**Lidl Ballymun MetroLink Site**

**ABP-314724**

**Attachment 4a: PUNCH Civil/Structural  
Engineering Report - Module 1**

**242119-PUNCH-XX-XX-RP-S-0002**

**Figure 2: Image taken from TII/JACOBS Railway Works Metrolink - Property Details Gulliver's Retail Park (Plan Number ML-P 303 K-L) and Railway Works Metrolink - Property Details Northwood (Sheet 1 Of 2) (Plan Number ML-P 303 L-M)**

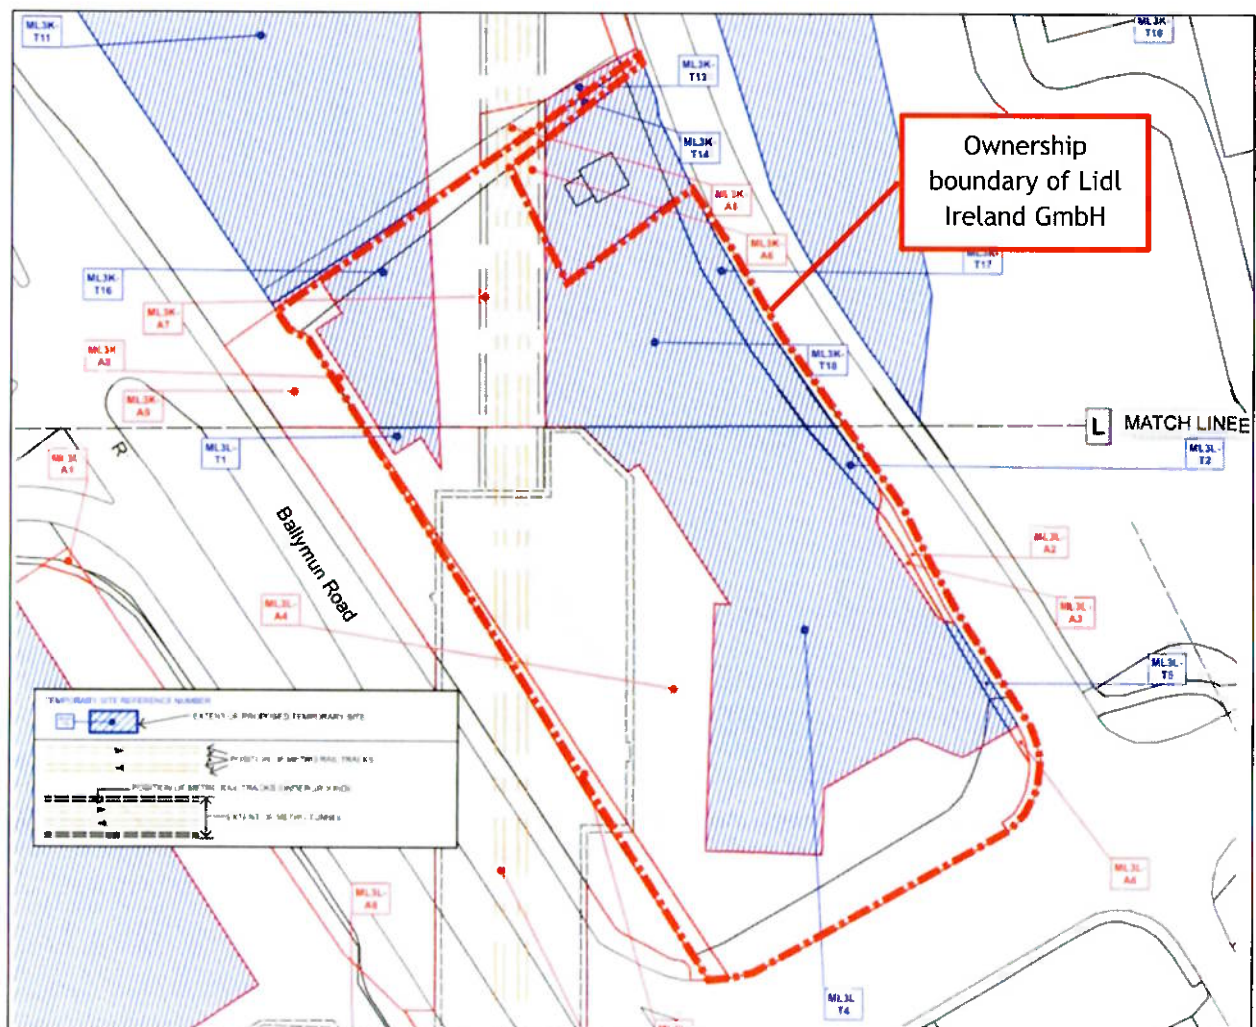
Figure 2 below shows the extent to which Lidl's site in Ballymun is to be impacted by the installation of the Northwood station, and also the area that is proposed to be taken as a temporary site to facilitate a contractor's compound during the construction of the MetroLink project. Historical mapping indicates the site has not been developed on, and therefore, the risk of pre-existing contamination on the existing site is low.

The long-term impact of the construction activities that will be carried out on site will change the existing use of the site from greenfield to non-greenfield. As set out in the EPA's "Guidance on waste acceptance criteria at authorised soil recovery facilities" there is significantly higher requirements for soil testing and classification in the removal of non-greenfield soil and stone waste than there is for removal of greenfield soil and stone.
